Historical Resources Board

DATE ISSUED: March 18, 2014 REPORT NO. HRB-14-023

SUBJECT: ITEM #10 – 1845 29th Street

DESCRIPTION: Consider the designation of the property located at 1845 29th Street as a

1845 29TH STREET Photo Comparison of Late 1980s and 2014

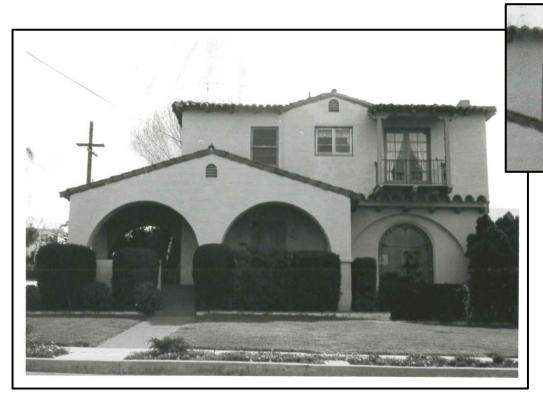
During the February site visit in preparation of this report, staff noted a significant discrepancy between the existing building and a photo included in the applicant's report taken in the late 1980s. This photo shows a pair of 3-lite casement windows centered under the front gable on the second floor of the main façade. Since the photo was taken, these paired casements were infilled, and the small octagonal window added. A comparison has been provided in Attachment 2. According to the consultant, this was done to accommodate a bathroom remodel. This modification was unknown at the time the building was previously reviewed by staff and the DAS during the restoration efforts. The photo also reveals the presence of wrought iron detailing at the fixed arched window on the main façade, which is no longer present. Additionally, staff noted some discrepancies in the treatment surrounding the windows throughout the house. The windows at the upper level behind the chimney are replacement windows which do not have the wooden sill found on the original window and the restored windows. However, these replacements do have a slightly sunken, beveled treatment (also seen in the 1980s photograph), which is missing on the restored windows that are set flush against the wall. This raises concerns regarding the window restorations and whether they were set appropriately and accurately in the building wall.

While the owner has undertaken restoration efforts that have significantly improved the design, materials and feeling aspects of integrity, the recent discovery of the window alteration at the front façade; the removal of the wrought iron detailing; and the questions regarding accurate treatment of window surrounds, taken together with the previously known modifications, result in significant cumulative impacts to the building's integrity related to its original Spanish Eclectic design. Therefore, staff does not recommend designation under HRB Criterion C at this time, due to a lack of integrity.
